# UNITED STATES PATENT AND TRADEMARK OFFICE

APPLICATION NO.	FILING DATE	FIRST NAMED INVENTOR	ATTORNEY DOCKET NO.	CONFIRMATION NO.
10/551,390	09/29/2005	Higashi Ko	HEI-011	3327
32628 7590 07/11/2007 KANESAKA BERNER AND PARTNERS LLP 1700 DIAGONAL RD SUITE 310 ALEXANDRIA, VA 22314-2848			EXAMINER BARLOW, MONICA L	
			ART UNIT 3609	PAPER NUMBER
			MAIL DATE 07/11/2007	DELIVERY MODE PAPER

## **DETAILED ACTION**

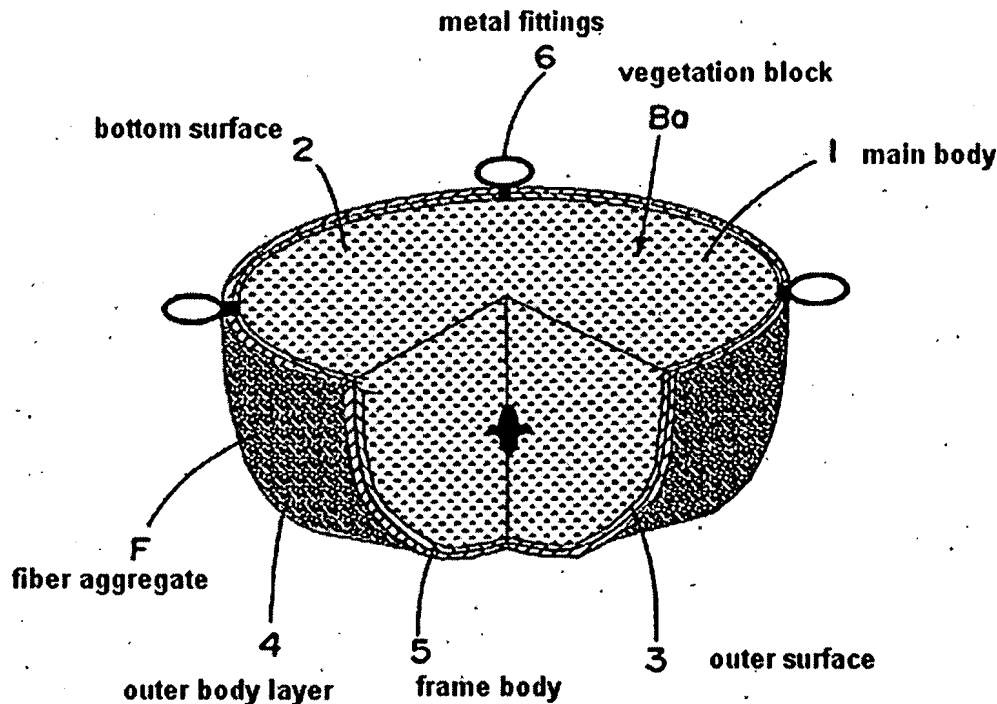
4. In re claims 1,3, and 13, with reference to modified Figure 1 shown below, Ko discloses a vegetation block with a main body formed of concrete, an outer layer of mat shaped fiber aggregate shaped similar to the outer surface of the main body.

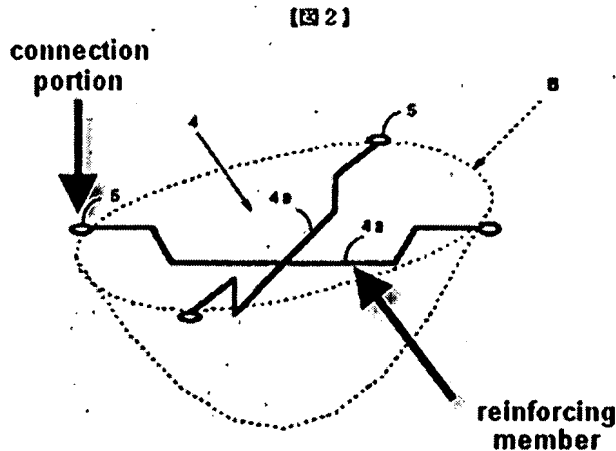
6. In re claims 10-12, with reference to modified Figure 2 shown below, Ko discloses a reinforcing member embedded in the block main body with a ring shaped connection portion which outwardly projects from the main body.
